### Proposed Revisions to a Standard Plans Index

Index Number: 700-010

Index Title: Single Column Ground Signs

**Summary of the changes:**

DRIVEN POST DETAIL (Frangible Post In Through Sidewalk Shown Installations without Sidewalk Similar)

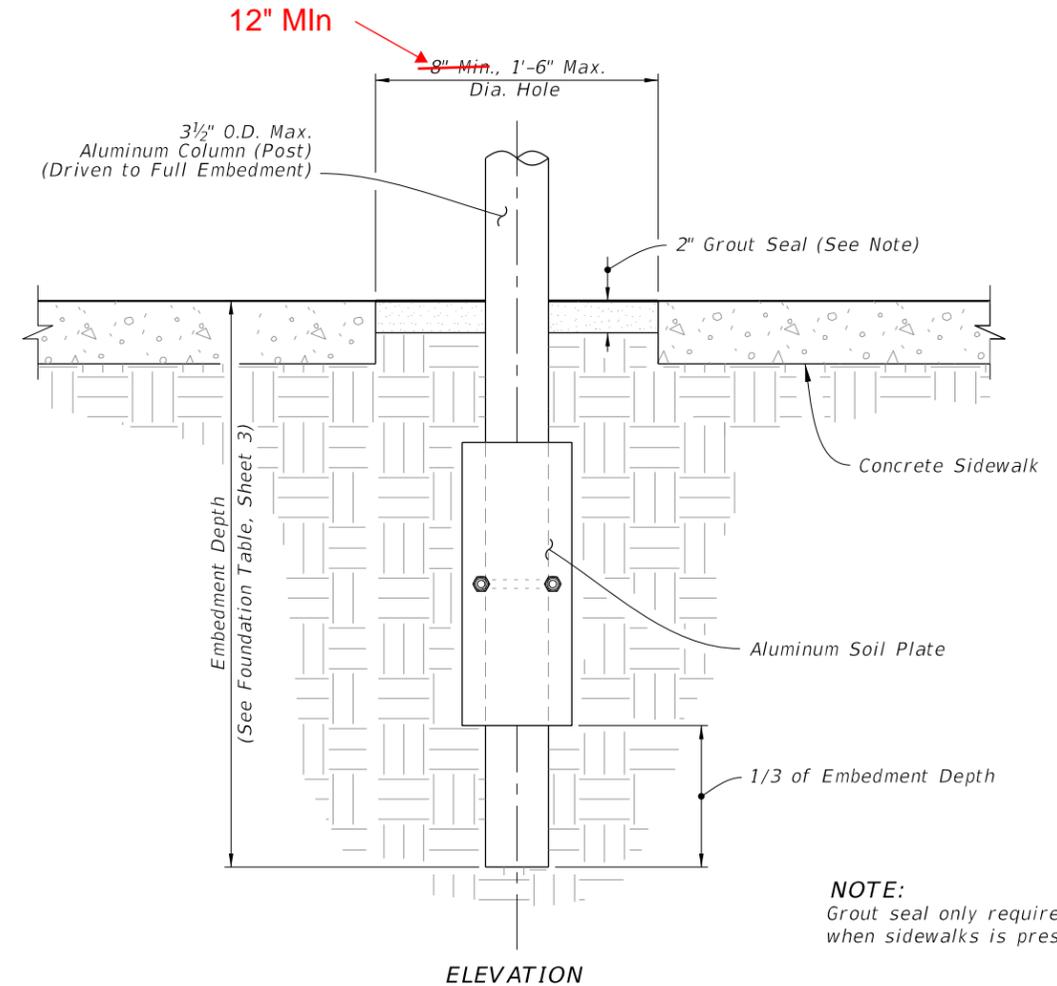
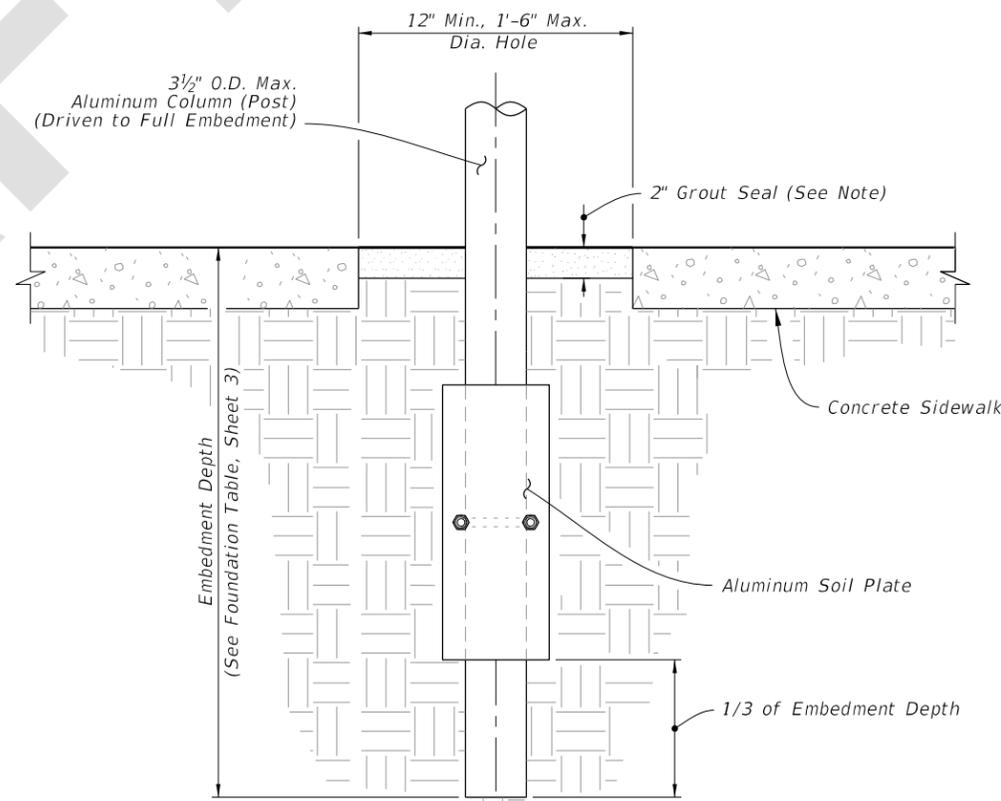
Change minimum Driven Post Hole Diameter to 12"

This change was requested by D7 Operations and coordinated with CO Maintenance and Construction. The 8" hole does not allow adequate space to remove old columns for replacement.
